WIDEFIELD WATER AND SANITATION DISTRICT
ROLLING HILLS 2MG POTABLE WATER TANK
LANDSCAPE PLAN

80% DESIGN

WIDEFIELD WATER AND SANITATION DISTRICT
ROLLING HILLS 2MG POTABLE WATER TANK
LANDSCAPE DETAILS

C16
SHEET 19 OF 32

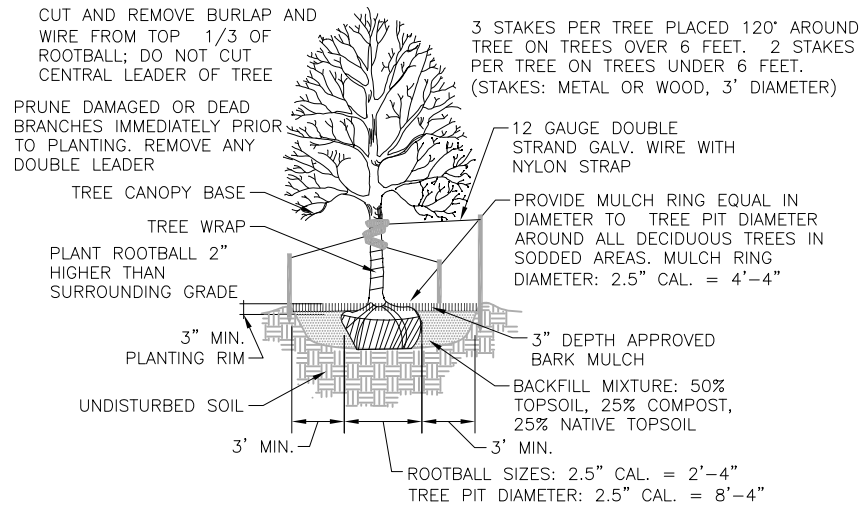
Please specify which type of native seed mix you are proposing. You can copy from GEC plan onto landscape plan notes on pg. 3.
